## NMF Soundness Consultation

Please find attached our submission to the reg. 19 consultation on New Monks Farm allocation.

# Amendments to the Proposed Submission Adur Local Plan (2016)

Concerns in relation to flood risk and drainage have been raised in regards to a strategic site known as New Monks Farm. The site is located to the east of Lancing, Worthing at National Grid reference 519394E 105413N. A site location plan is provided as Figure 1 below:

**Figure 1** – Location Plan – New Monks Farm

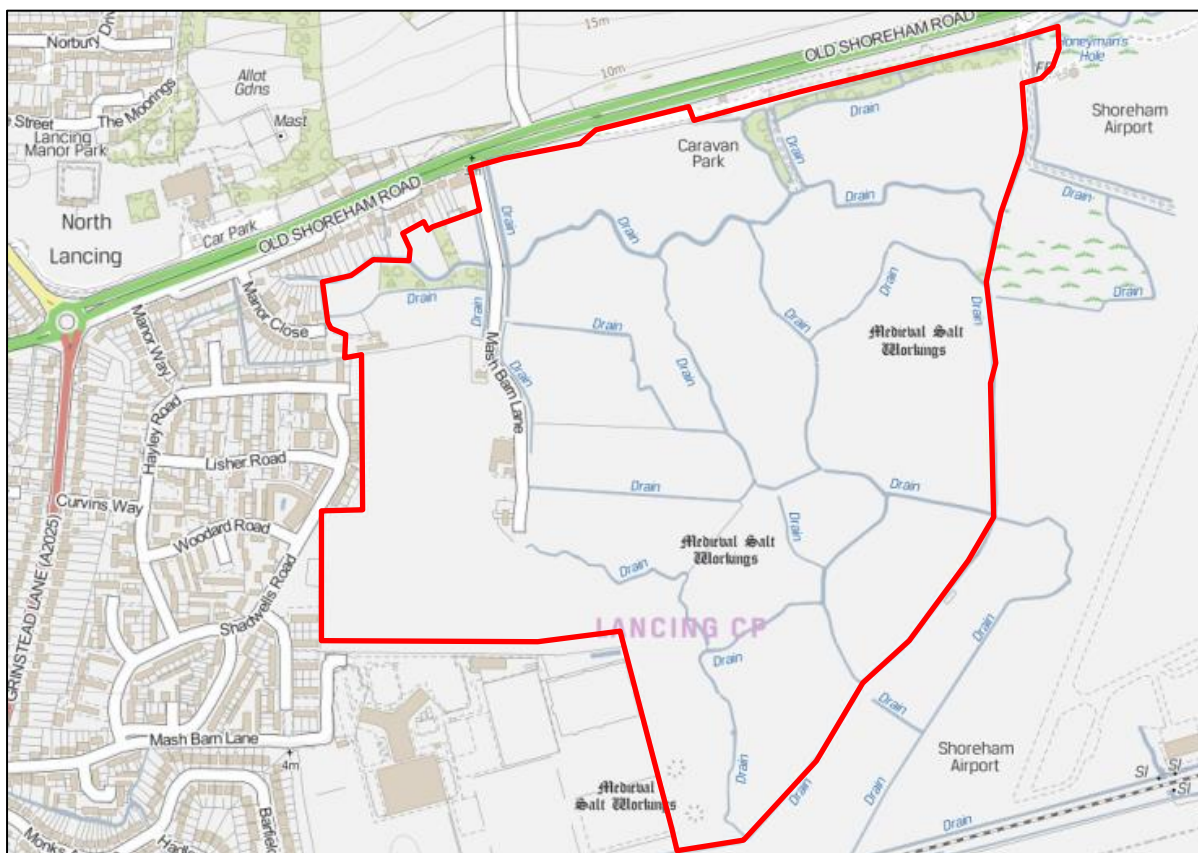
- 1) **Flood Risk:** Advise on the adequacy of the above assessments to; support the site allocation within the Adur Local Plan; demonstrate compliance with National Planning Policy Framework (NPPF) (paragraph 102) and the Planning Practice Guidance (PPG): Flood Risk and Coastal Change.
- 2) **Drainage:** Analyse the West Sussex County Council Lancing Surface Water Management Plan (CH2M Hill, September 2015) to assess whether it supports the findings of previous studies, namely the Ambient Flood Risk Assessment Report (November 2014) which concludes that:

Approximately 85% of the site is located within Flood Zone 3a on the Environment Agency Flood map for Planning (Rivers and Sea) – an area considered to be at high risk of tidal flooding with a 0.5% annual probability or greater of flooding in any given year.

**Figure 1.1 Allocation areas**

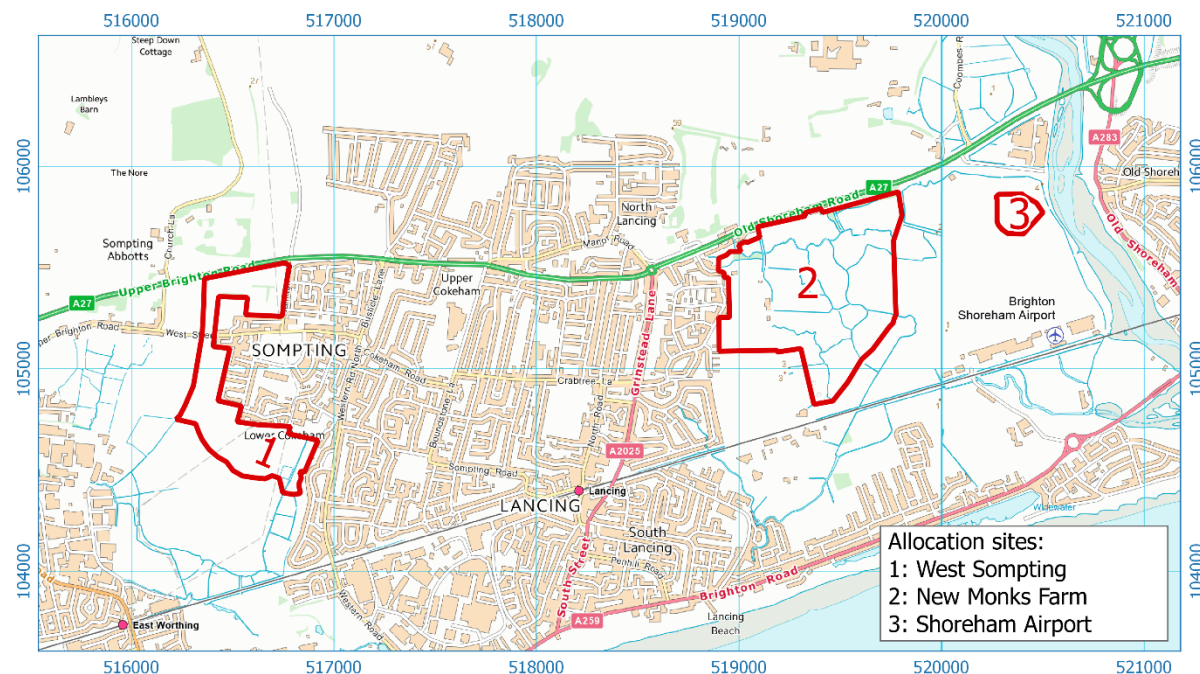
Major site allocations have been proposed in the Adur Local Plan (consultation draft). There are local concerns that surface and groundwater flooding has not been adequately taken into account by the Council and that the key strategic sites at New Monks Farm, land west of Sompting, and Shoreham Airport are therefore not demonstrably deliverable.

The Adur Local Plan<sup>3</sup> identifies three greenfield sites for development: New Monks Farm, land west of Sompting, and Shoreham Airport (Figure 1.1).

Figure 1.2 Geology and hydrology (2.5 x vertical exaggeration)

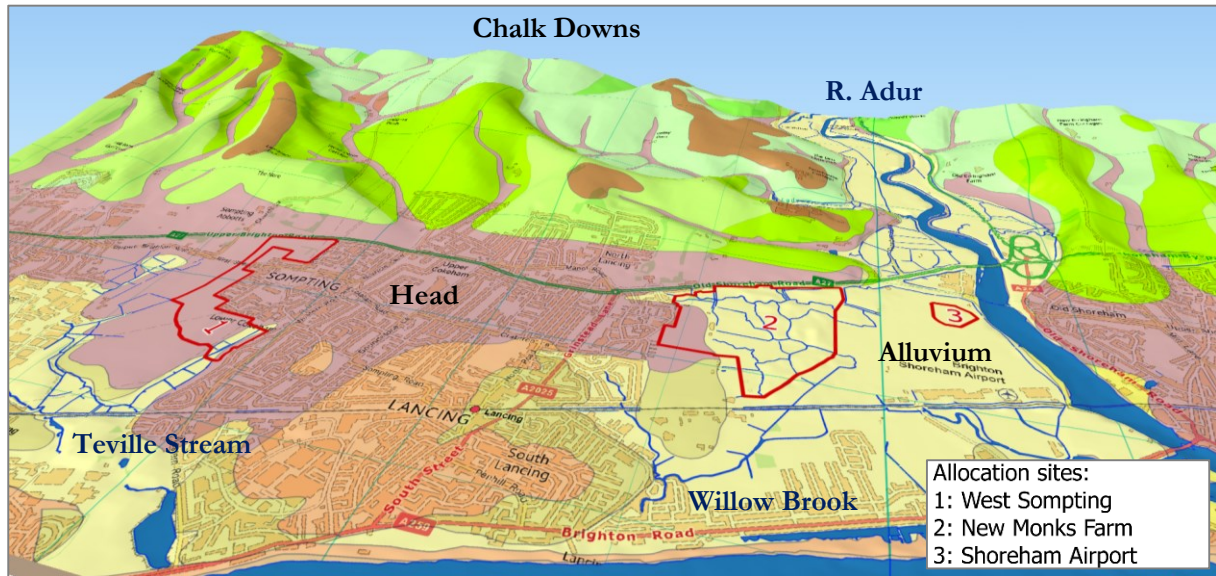
Bedrock geology at all three sites comprises Chalk (Figure 1.2), which is a very permeable rock and forms the principal groundwater supply for Southern and South East England. West of Sompting the Chalk is overlain by Head, which is a superficial deposit comprising mixed sand, silt and clay that develops from sub-aerial weathering of the hills that form the South Downs. East of Lancing the Chalk is overlain by alluvium. This is, again, a mixed sand, silt and clay deposit, which forms by deposition from rivers. Extensive drainage in the Willow Brook catchment suggests that the alluvium has in places rather low permeability.

Figure 1.3 Schematic north-south cross-section of site geology

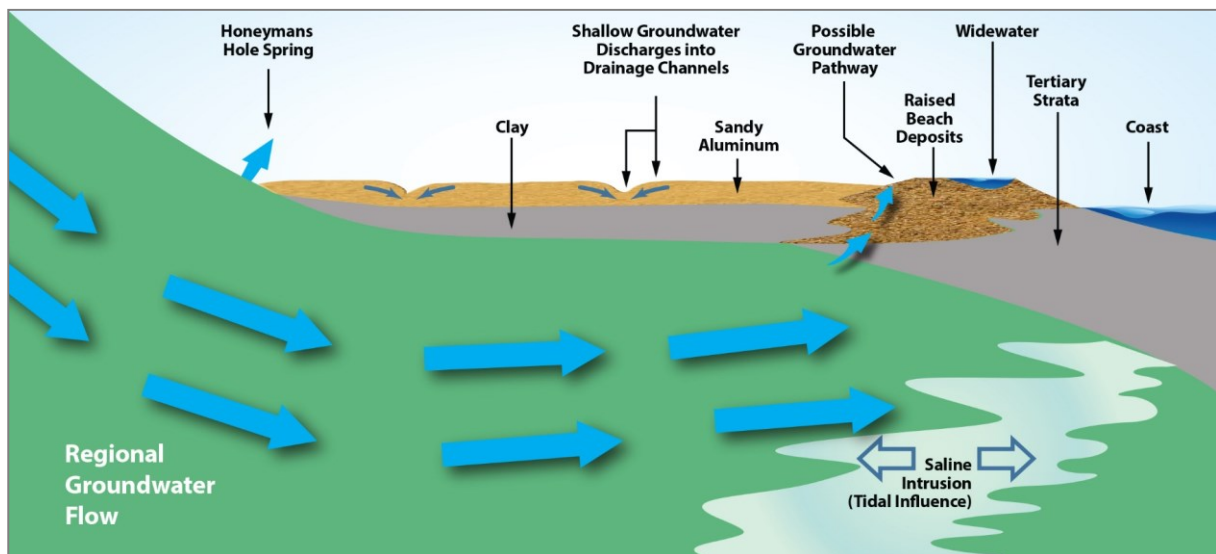
The conceptual model presented for the Lancing Surface Water Management Plan (CH2MHill, 2015) is a good cross-section of the site geology (Figure 1.3). This shows groundwater moving southwards from the topographic high of the South Downs, underneath the low permeability sediments of the coastal plain. Springs emerge at the position where the chalk outcrop dips under the superficial sediments (Honeymans Hole Spring here) and at any location where there is a permeable pathway out to the coast.
